SERVICE BULLETIN ASM-005

Product: Antenna System Monitor

Subject: Firmware 2.0 Release

- i) Activity Indicator (“Act”)

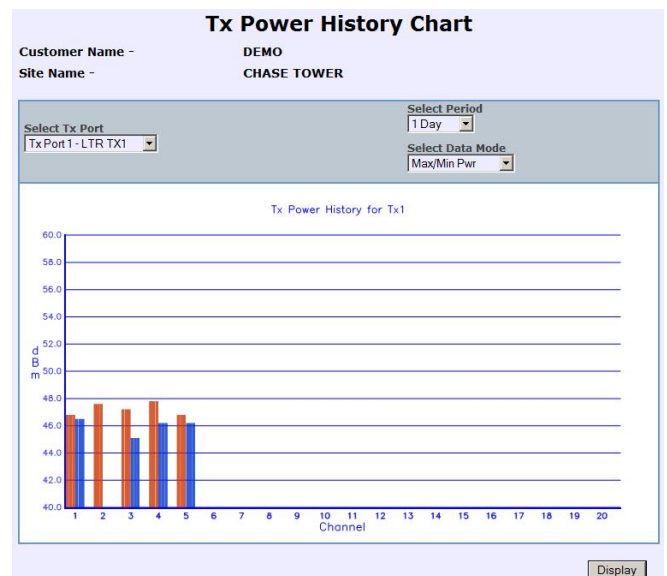
This feature provides an indication of the currency of the *Last recorded activity above threshold* value being displayed in the Status screens. If the Act indicator is lit, the value displayed was measured in the last measurement cycle. If the indicator is dim, the value displayed is aged. If the indicator is not displayed at all against any channel line, then that channel is currently disabled and is not being included in measurement cycles.

- ii) New History Chart

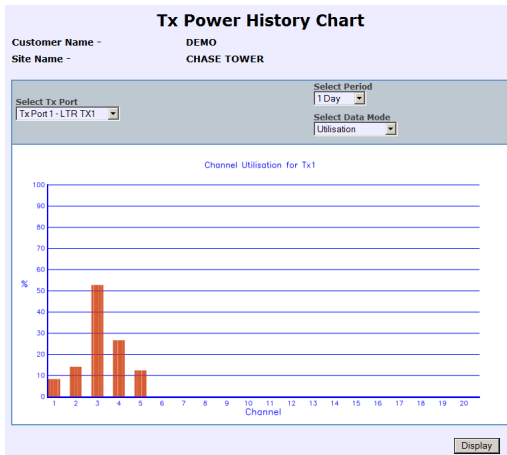
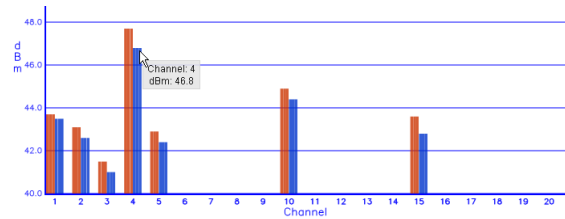
Two History Chart types are now available; Max/Min Power, and Channel Utilisation.

Max/Min shows the maximum and minimum Tx Power measured for each channel on the selected port – over the selected period. This data can indicate Tx PA power sag, combiner insertion loss drift, or other conditions that may be causing variable RF output power.

Hovering the mouse cursor over the upper portion of a bar will display its actual value.

Utilisation shows a representation of the duty cycle of each channel on the selected port – over the selected period. This data can be used to indicate the loading on each channel being monitored and can assist in assessing busy traffic periods or congestion.
